**ADDENDUM NUMBER:** Three (3)  
**DATE:** February 3, 2026  
**PROJECT:** Interior Renovations for Montgomery County Assessor of Property  
**DESIGNER:** DOUGLAS A. JONES, ARCHITECT  
 MONTGOMERY COUNTY ENGINEERING  
**BID OPENING:** February 10, 2026, at 2:00 P.M.

**TO PLANHOLDERS:** This addendum is issued to modify the original Project Manual and Project Drawings dated January 14, 2026, and is hereby made part of the contract documents. Acknowledge receipt of this Addendum in the space provided on the Bid Form. Failure to do so may subject the Bidder to disqualification.

CEILING DEMOLITION PLAN  
INTERIOR RENOVATIONS FOR  
MONTGOMERY COUNTY ASSESSOR OF PROPERTY  
350 PAGEANT LANE, SUITES 401 & 402  
CLARKSVILLE, TENNESSEE

**A4.1**

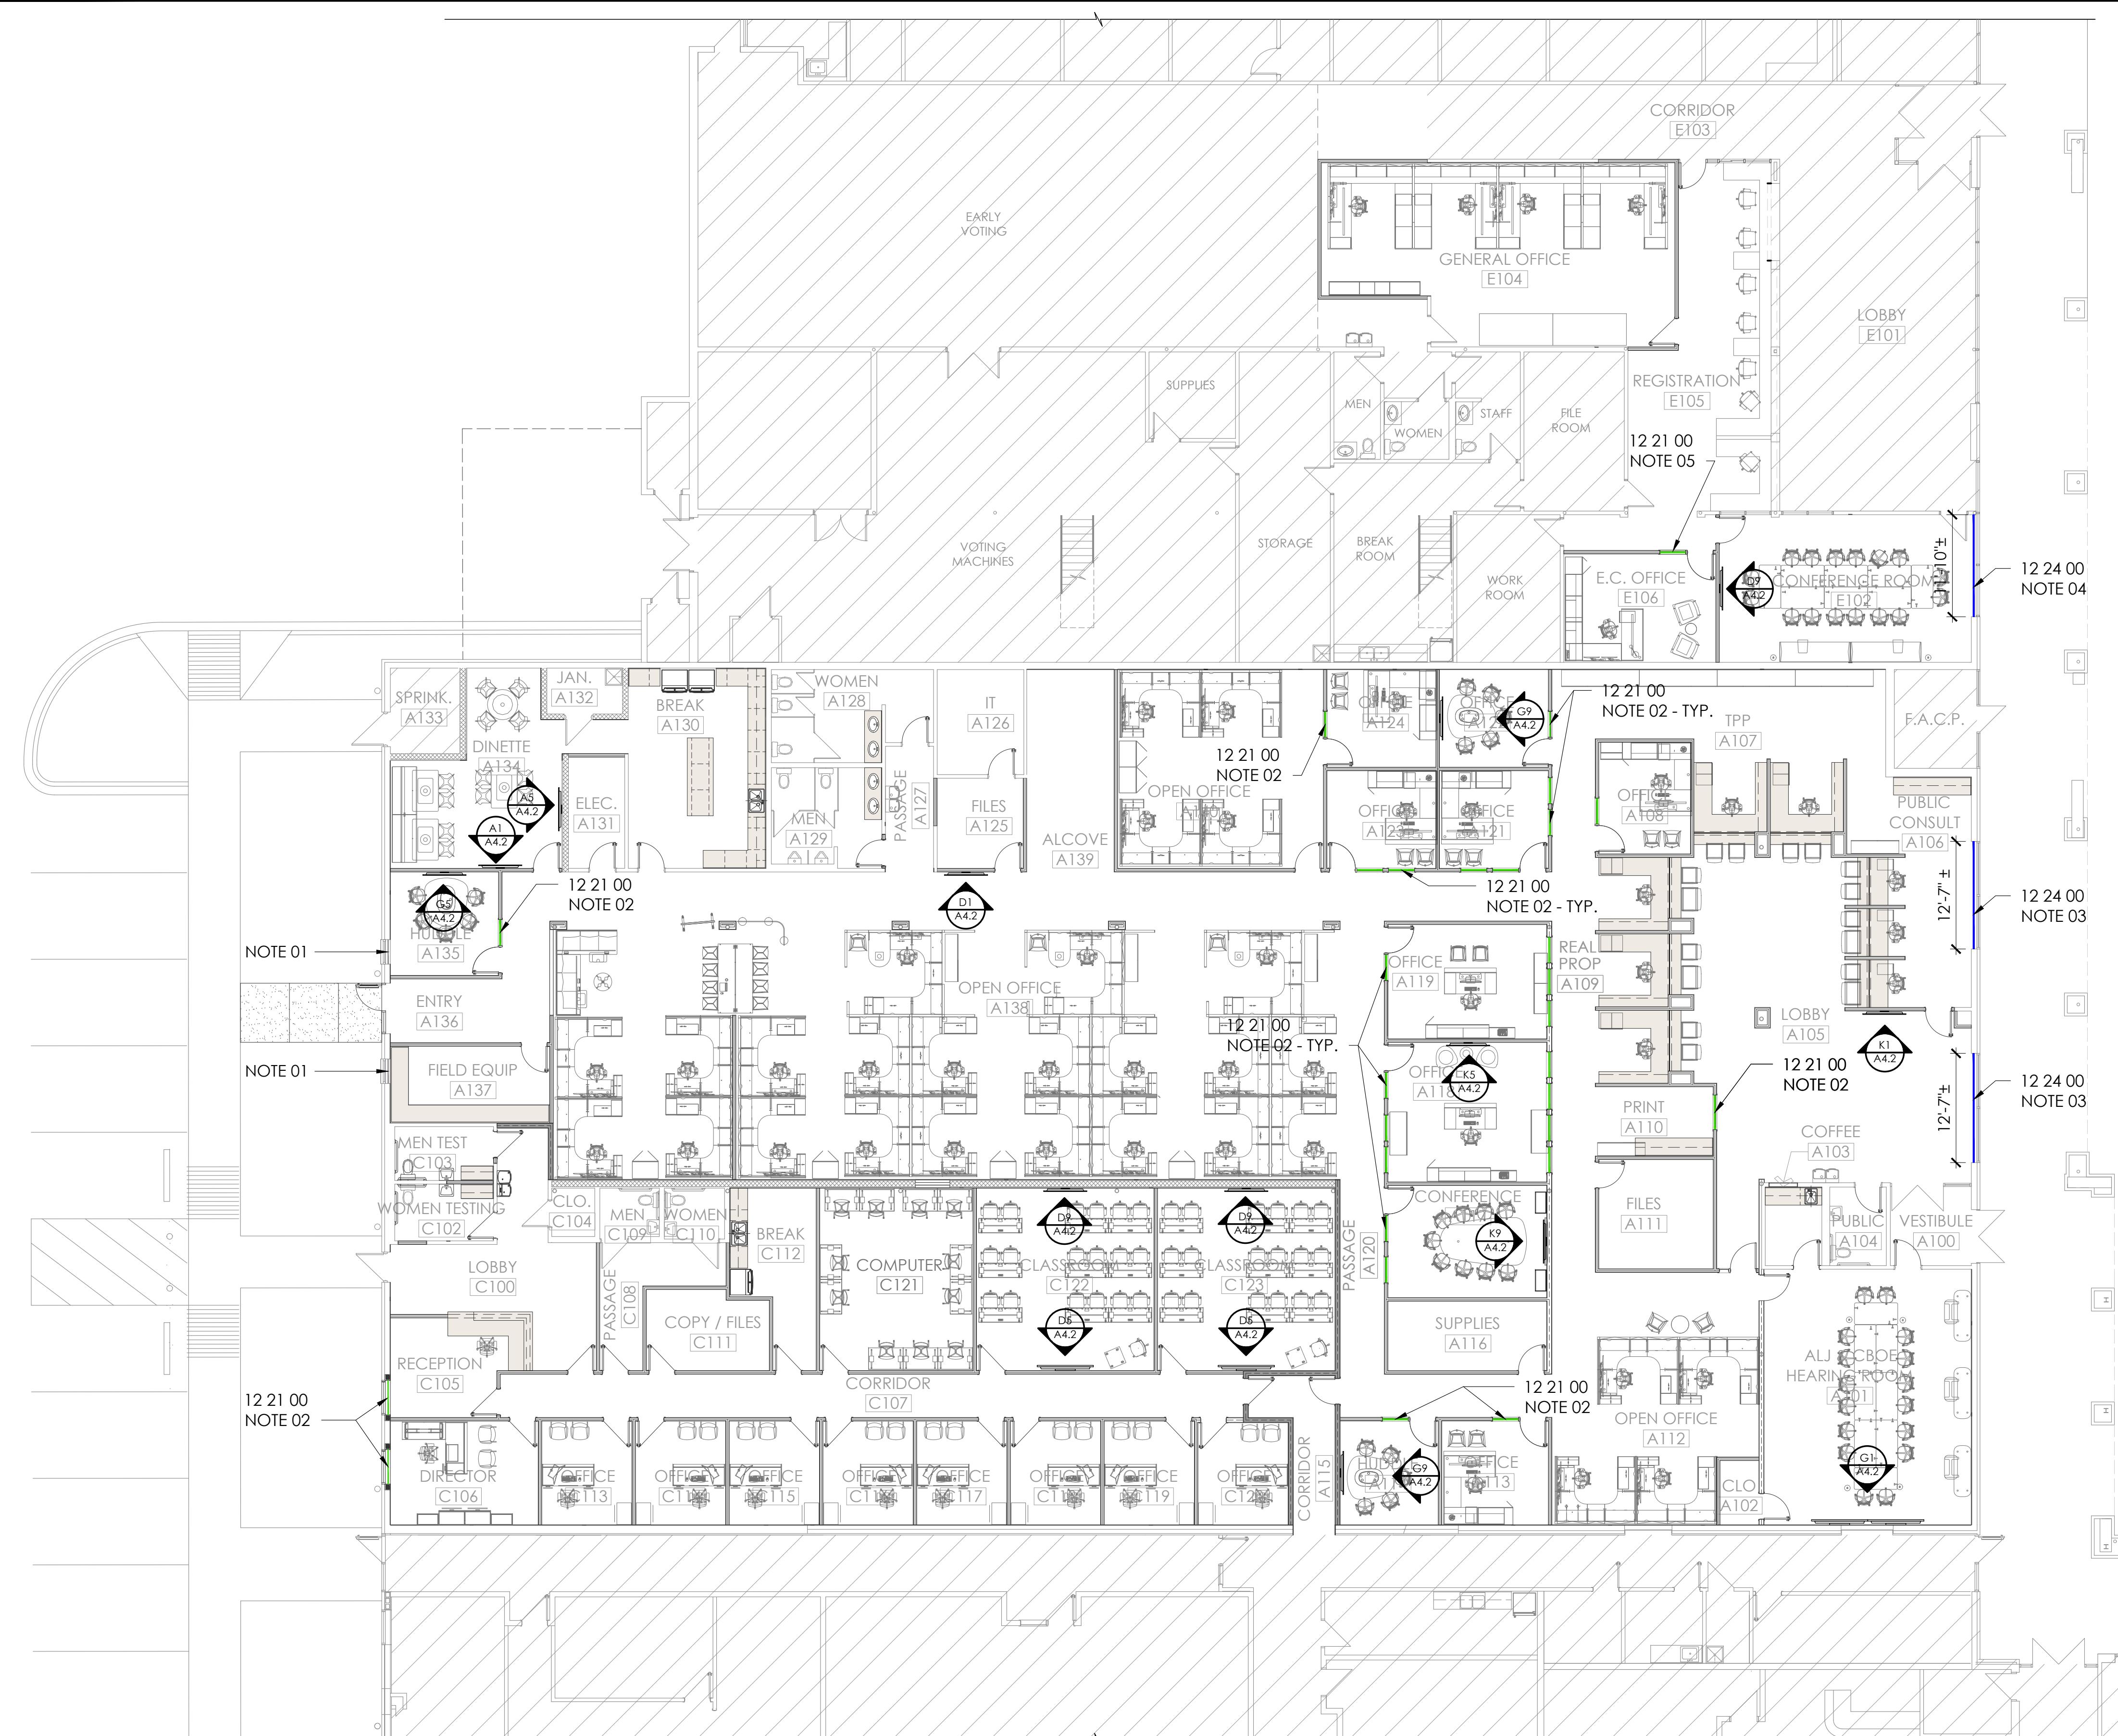
SHEET A4.1 FURNISHINGS & EQUIPMENT PLAN; Delete Sheet A4.1 dated 01/14/2026 and Substitute Therefor Sheet A4.1 Dated 2/3/2026 attached hereto.

Clarification: The N.I.C. Furniture Layout has been revised.

N.I.C. FURNITURE LAYOUT HAS BEEN REVISED. 3

**G1** HEARING ROOM A101

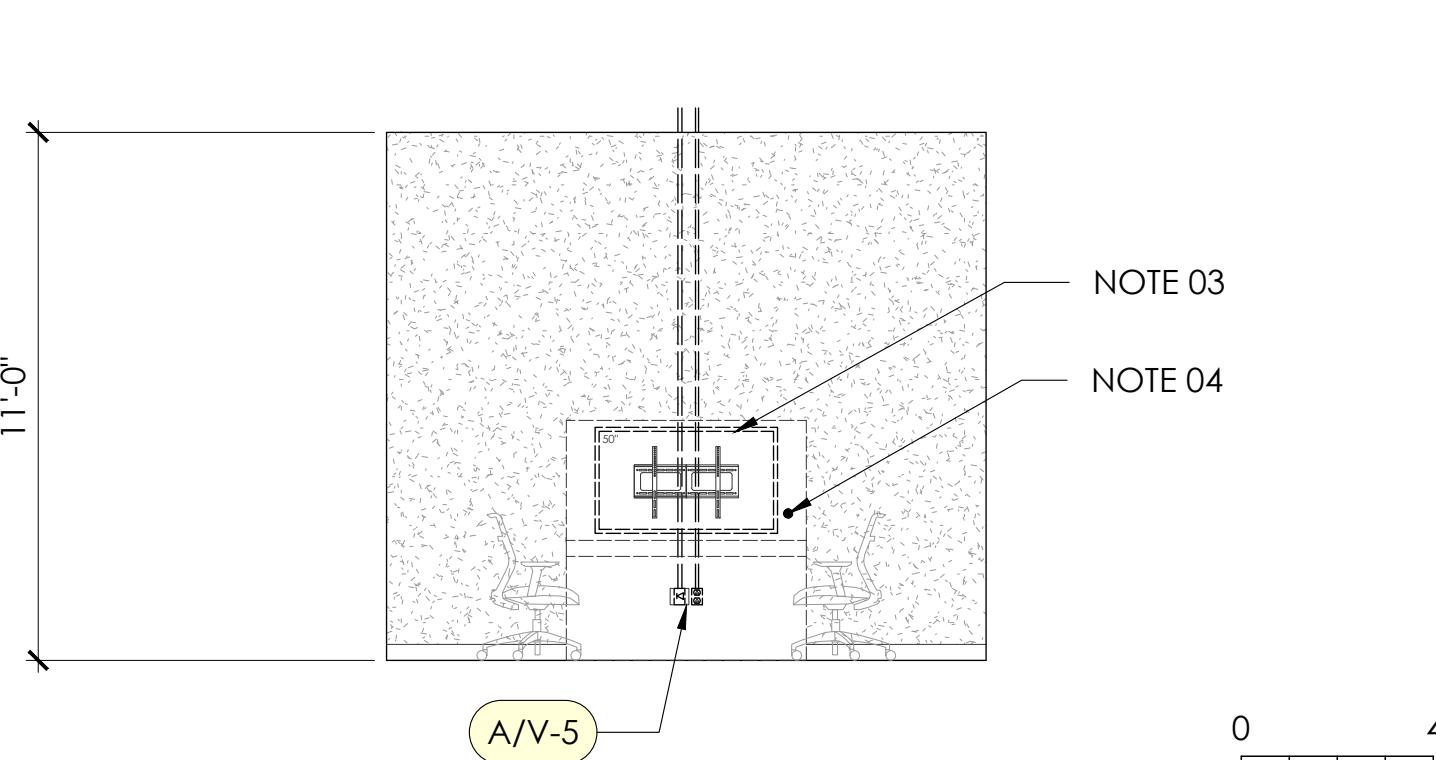
SHEET A4.2 A/V COORDINATION; Delete Sheet A4.2 dated 01/14/2026 and Substitute Therefor Sheet A4.2 Dated 2/3/2026 attached hereto.

Clarification: Low power, Data & HDMI have been added for a Podium Connection to Hearing Room A101.

**E-1**

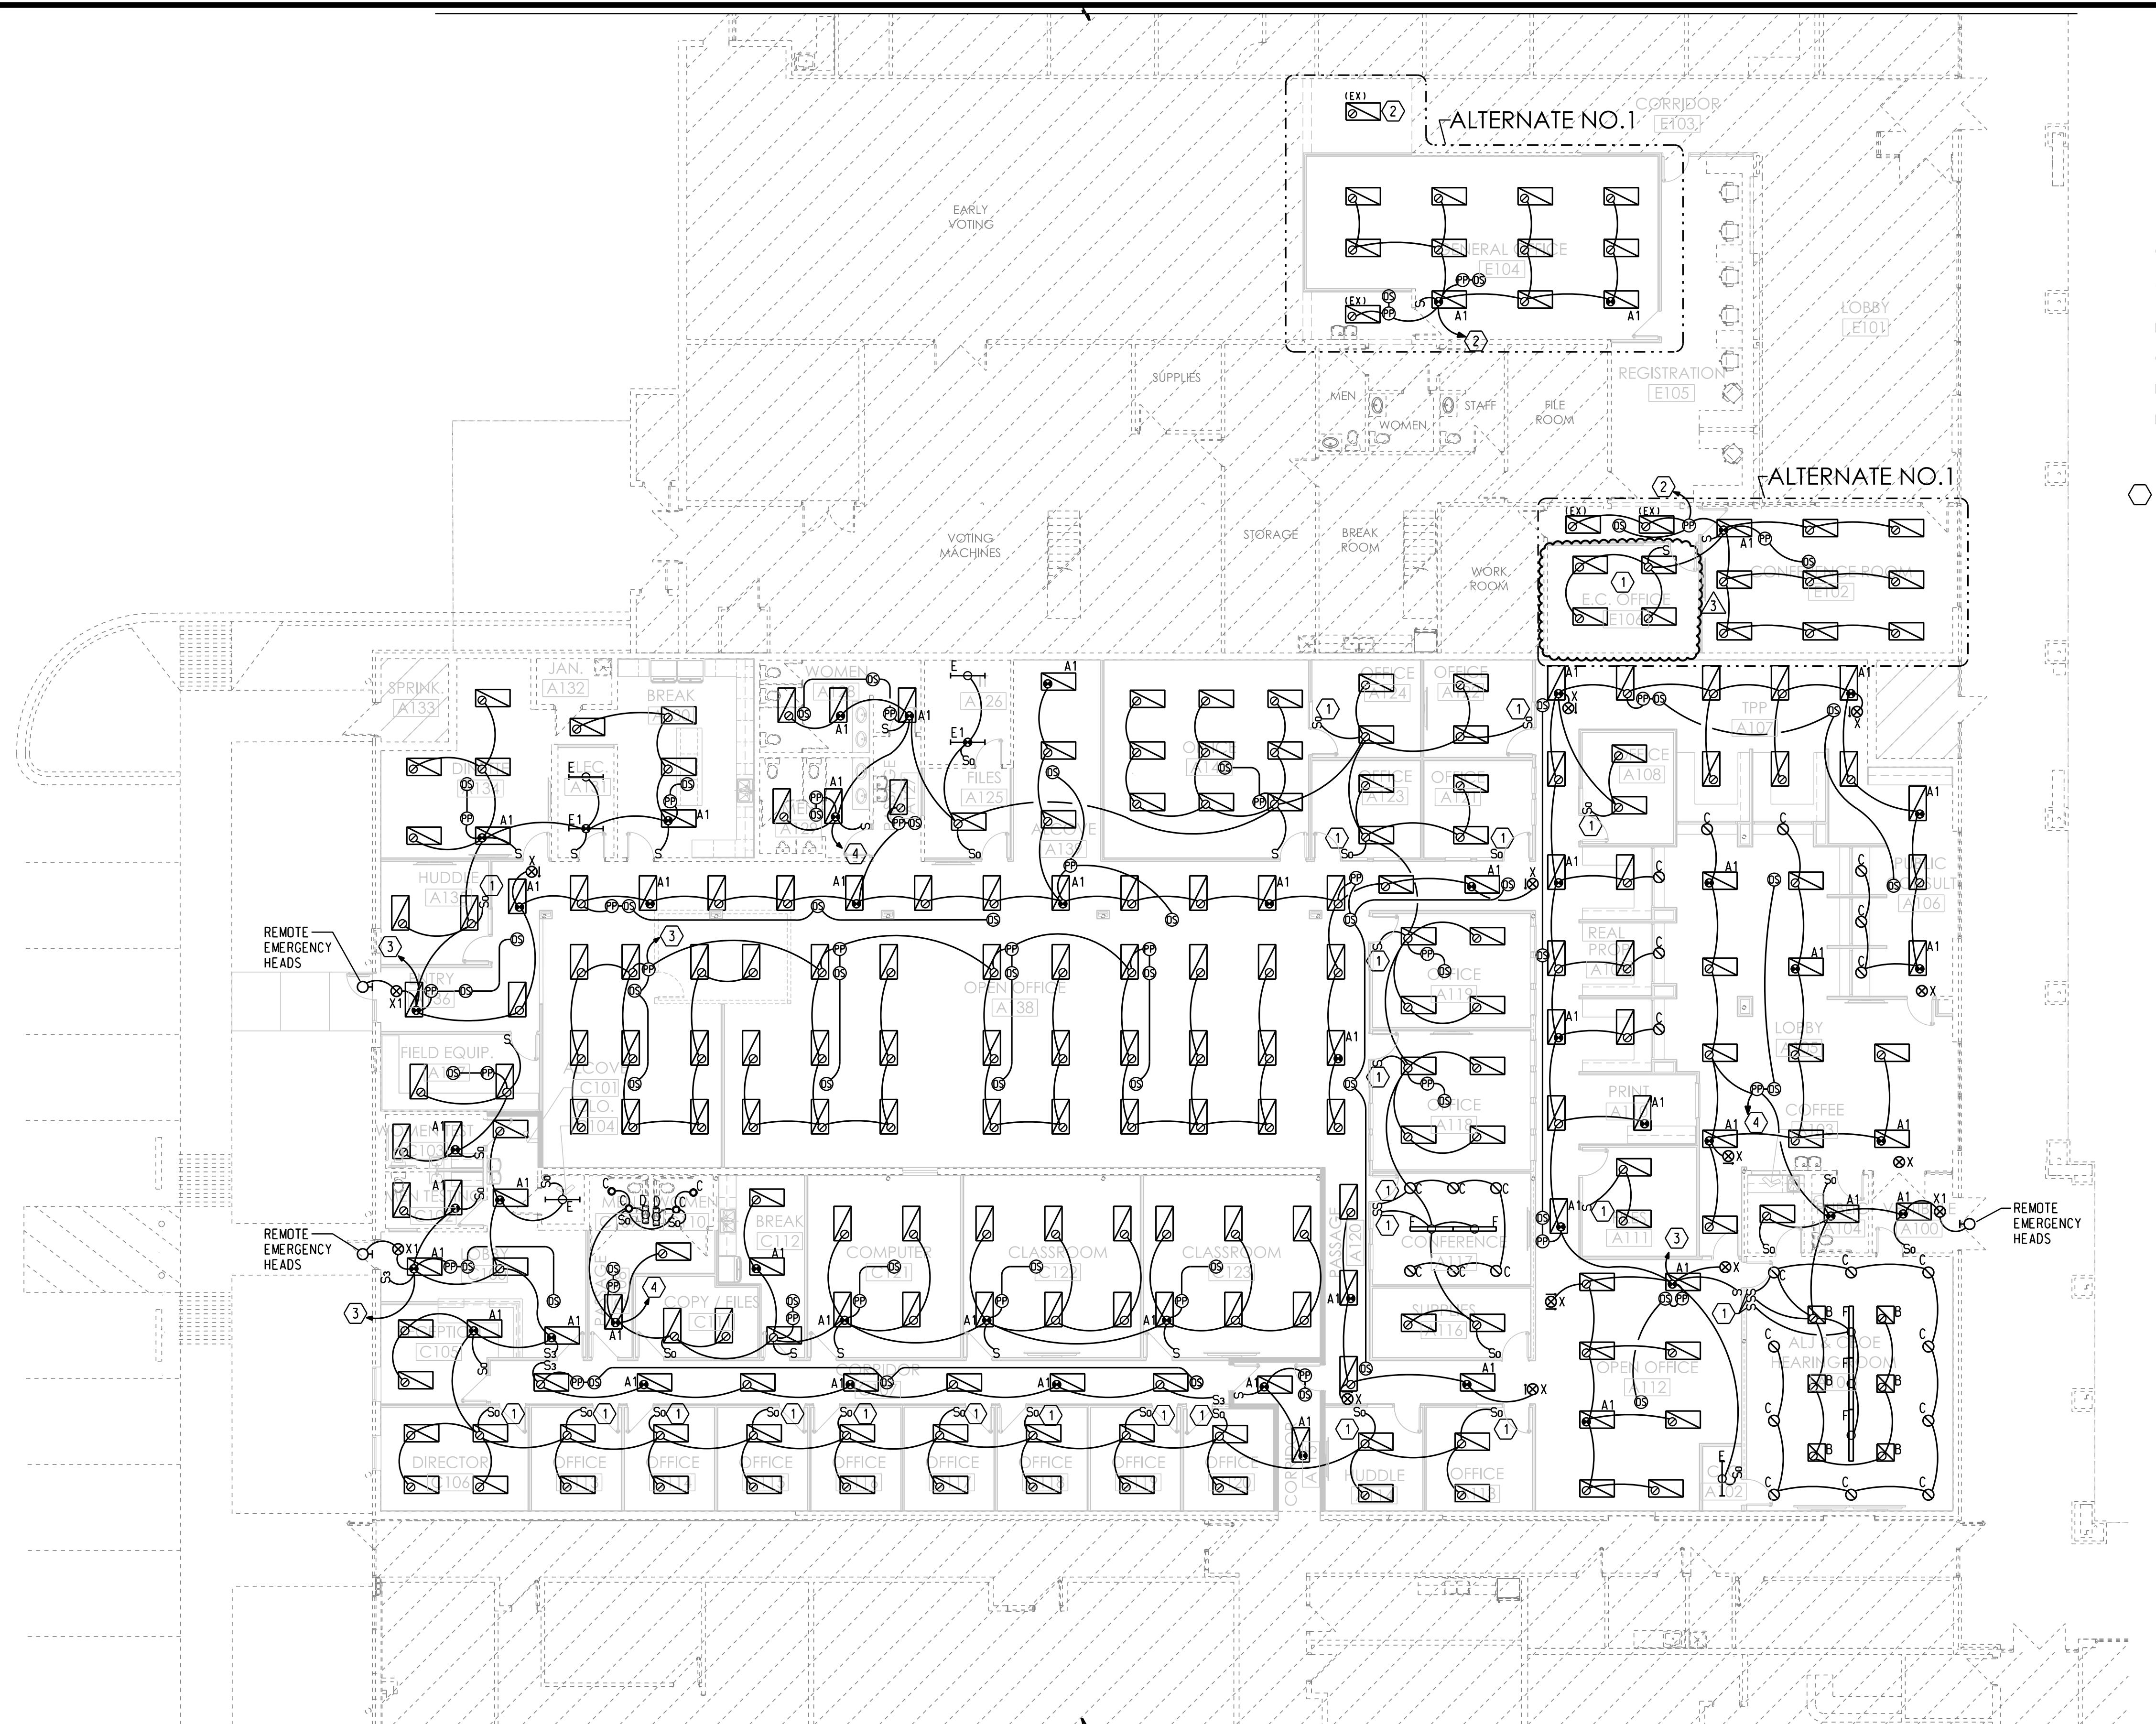
SHEET E-1 LIGHTING FLOOR PLAN; Delete Sheet E-1 dated 01/14/2026 and Substitute Therefor Sheet E-1 Dated 2/3/2026 attached hereto.

Clarification: General Electrical Revisions.
